Re: Final Land Development - Blue Rock at Elverson
Elverson Borough - LD-04-20-16319

A final land development plan entitled "Blue Rock at Elverson", prepared by Ludgate Engineering Corporation, dated January 10, 2006 and last revised on October 25, 2019, was received by this office on April 16, 2020. This plan is reviewed by the Chester County Planning Commission in accord with the provisions of Section 502 of the Pennsylvania Municipalities Planning Code. We offer the following comments on the proposed land development for your consideration.

Detail of Blue Rock at Elverson Final Land Development Plan

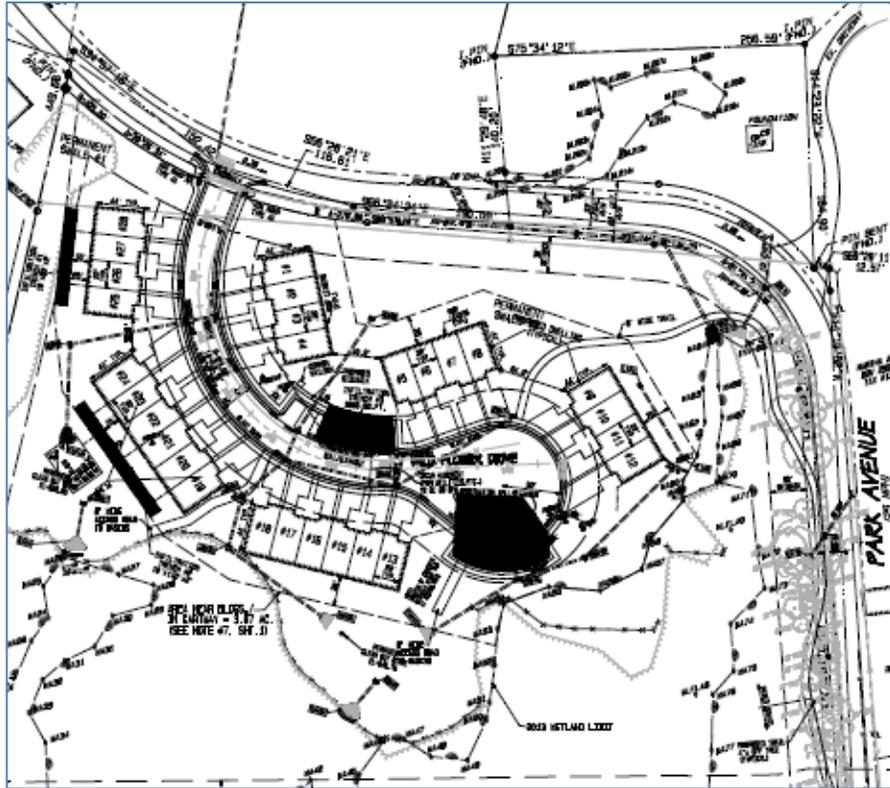
9. The plans indicate that the majority of roof leader drains will be directed into four subsurface infiltration trenches. The applicant should ensure that all roof leader drains will be provided with appropriate measures (e.g. leaf traps, gutter guards, or regular cleanouts) to prevent clogging. Requirements for regular inspections of roof drains should be included in the operation and maintenance plan to ensure these systems maintain their designed functions.

10. The two stormwater basins located on the southern end of the parcel are planned as detention basins that will be lined with impervious clay liners. Infiltration rates determined from on-site percolation tests (1.75 to 6.88 inches per hour) and information contained in the USDA's Soil Survey (well-drained Neshaminy silt loam) indicate that this site may support stormwater infiltration. Unless site conditions are not conducive to infiltration at the location of these basins, the applicant should consider designing and installing them as infiltration basins. This will maximize the infiltration of stormwater from the site and will minimize the hydrologic impacts to the down-gradient wetlands.

12. Stormwater runoff from Park Avenue will be discharged into a delineated wetland at the outlet located at EW-N at the northeastern corner of the project site. The applicant should consider incorporating additional energy dissipation measures, such as a level spreader similar to the one planned at EW #4, to reduce discharge velocity to prevent erosion from occurring in the delineated wetland.

*Detail of the Map 8-B
Recreation and Open Space Plan in the
2104 Elverson Borough Comprehensive Plan*

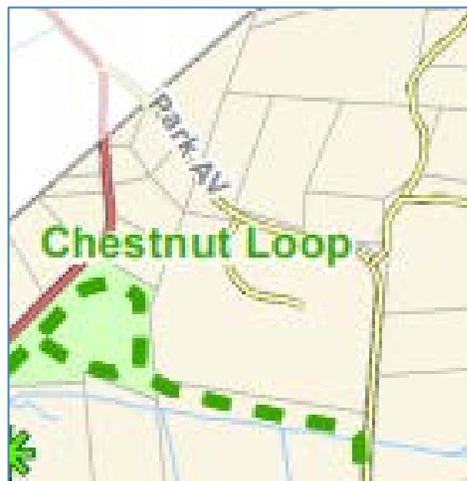
5. We endorse the planned connection to the proposed Chestnut Loop trail as shown in Map 8-B Recreation and Open Space Plan in the 2104 Elverson Borough Comprehensive Plan (see the detail below). We recommend that the entire length of the trail on the site should be paved instead of using gravel to minimize potential erosion and maintenance issues. The trail connection is also specifically mentioned in conditions 3 and 4 of the Conditional Use Order.
